Transportation Engineering Design Standards (TEDS) Exception Request

City File No.: TED- _____ (To be filled in by City Staff)
Project: 265 Gettysburg Street Fence
Site Address: 265 Gettysburg Street
Applicant: Josephine M Schleich
Representative: self
Date: 5/5/09
Parent Project:
Project Name: 265 Gettysburg St
City File No.: _____

Re: TEDS Exception-2009-111 – 265 Gettysburg

Transportation Engineering Design Standards (TEDS) Exception Recommendation Form

SCALE 1 : 240 **265 GETTYSBURG**

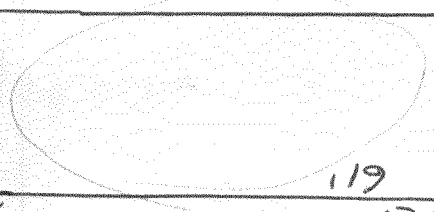
1. How will the exception affect safety? We have set the fence in 3 feet from the shared driveway and will angle the NW corner per the engineers recommendations (angulations on the map not exact-just a representation-engineer will give us specifics) to assure visibility for the only lot that would be affected (West lot). The fence is 29 feet back from the street so it will not affect street visibility from the shared driveway at all.

- Approve as requested.
- Approve with the following modification(s): Provide sight triangle in NW corner
- Deny.
- Hold until the following additional information is submitted and reviewed:

A mistake was made when the planning clearance was issued and the garage was allowed to access the street instead of the shared driveway as required by TEDS. The owner is wanting to fence along the shared driveway, 3' behind the concrete. The lot immediately west of this lot could have sight distance problems backing out of their garage depending on where the garage gets located when the house is built. This owner has agreed to provide a triangle in the fence to aid in sight distance. The recommended sight triangle is 5' north to south and 15' east to west. I am assuming a max speed of 10 mph in the shared drive. There are no standards in TEDS for a 10 MPH sight triangle but I am assuming 50' is adequate. This provides 50' depending on the length of backing car and garage location.

Provide 5' X 15' sight triangle per the attached sketch.
